## TAKACHI ELECTRONICS ENCLOSURE CO., LTD.

# NOTICE

## Changes to Material and Finish

■ **Affected** : HD series / 6 models

#### Current Material / Finish

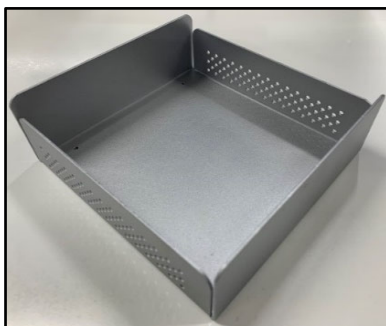
■ **Changes** : Base material and finish ONLY (Cover material and finish is unchanged).

Material	Finish
Aluminium A1050P	Metallic silver / Painted

Material	Finish
Aluminium A1100P	Metallic Silver / Painted Conductive inside

※Conductive inside for EMC shielding.

- **Functionality**: No changes to functionality, size or dimensions.
- **Purpose**: To ensure consistent quality throughout via streamlined supply chain and materials.
- **Period**: Once current inventory has been depleted.
- **Series / Model**: No changes to both Series, and Part numbering.
